Product change information (PCN)

PCN No.:	K03-13006	Date:	08.09.2017
Product:	3022218, 0802723

Order No.	Designation	As of product revision
3022218	CLIPFIX 35	01
0802723	CLIPFIX 35 WH	01

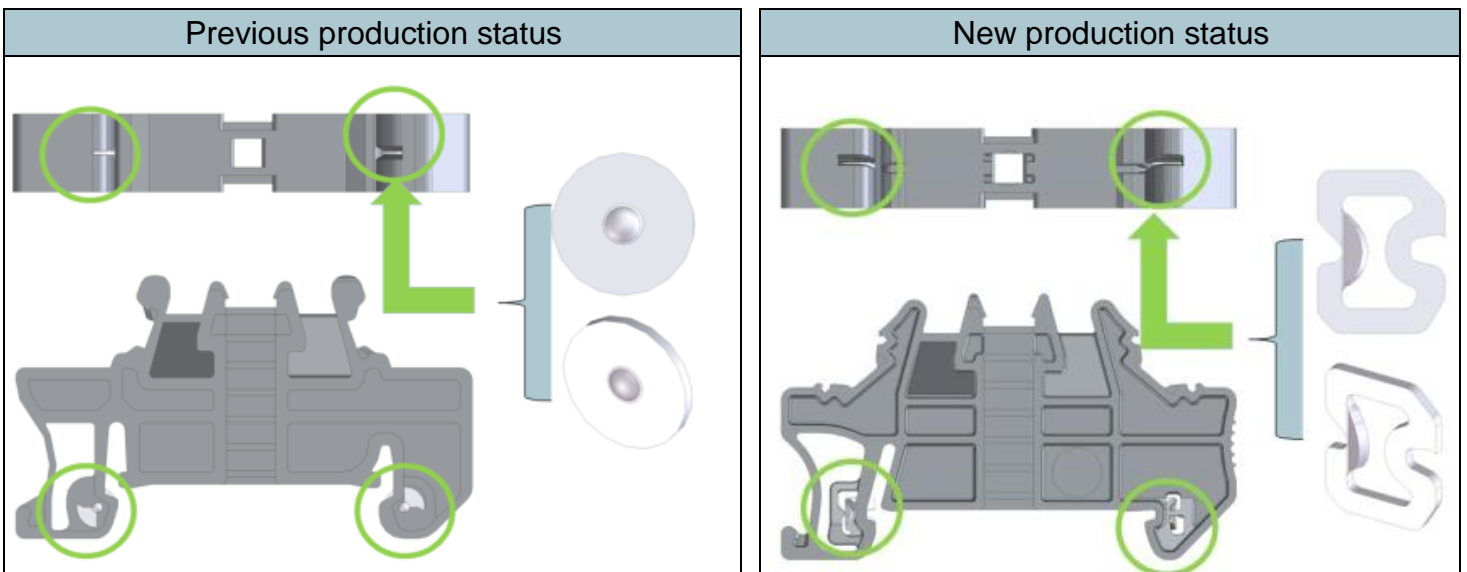
The displacement force is optimized by tilting the metals in the base and changing the metal geometry.

The marking options have been expanded to include TMT (EX9.5)R [0828295].

Light modification of the design due to tool enhancements.
